Rezoning Transportation Analysis

Petition Number: 2020-054

General Location Identifier: Tax ID 14525501

Revision Log:	Date	Description
	05-18-20	First Review

I-77 TYPICAL SECTION

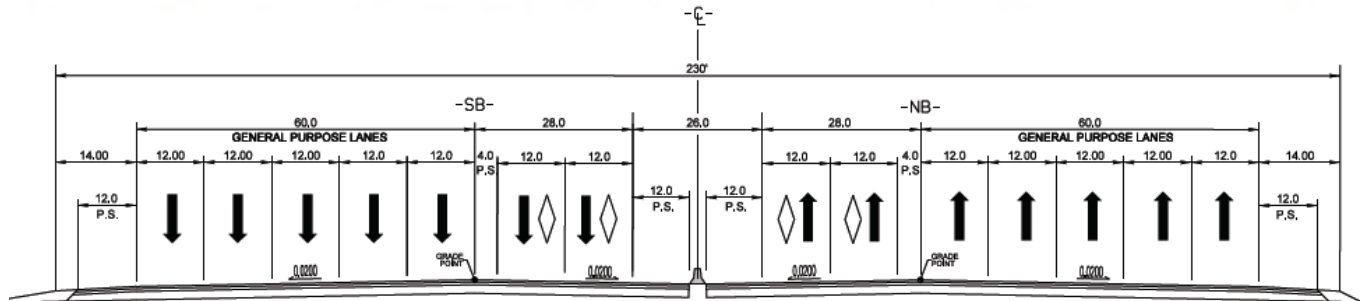
- I-77 Managed Lanes (TIP# I-5718A)
 - Widen existing freeway to ten lanes by constructing four managed lanes (two in each direction) – and rebuild the I-277 (Belk Frwy) interchange.
 - ROW in 2025 and Construction in 2029 (*Subject to change due to NCDOT funding issues*)
 - 2016 feasibility study (TIP #FS-0810A) shows additional ROW needed:

4. The petitioner should revise the site plan and conditional note(s) to confirm that there is a minimum of 230 feet of right-of-way is either currently reserved or will be dedicated from centerline for the future I-77 Managed Lanes Project (TIP# I-5718A).
